Subject: Proposed modification to M.1450-5

### PROPOSED MODIFICATION TO ANNEX 15 TO DOCUMENT 5A/597-E

WORKING DOCUMENT TOWARDS A PRELIMINARY DRAFT REVISION OF  
RECOMMENDATION ITU-R M.1450-5

### **Characteristics of broadband radio local area networks**

FIGURE 10A (#526)  
Transmit Mask for EN 302 567

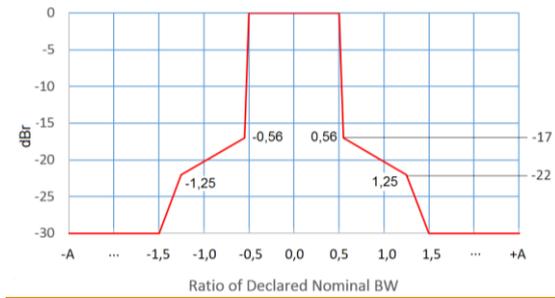
**Commented [SD12]:** Inserted as Figure 10a

Transmit Mask for EN 303 722

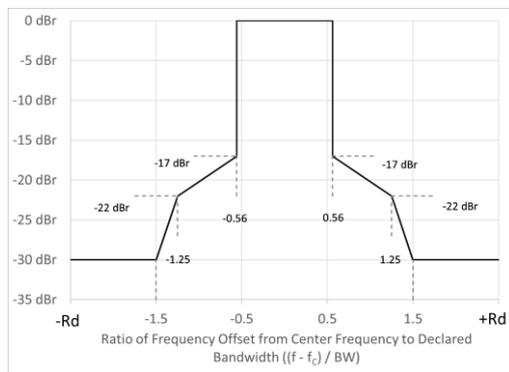
**Commented [SD13]:** Inserted as Figure 10b
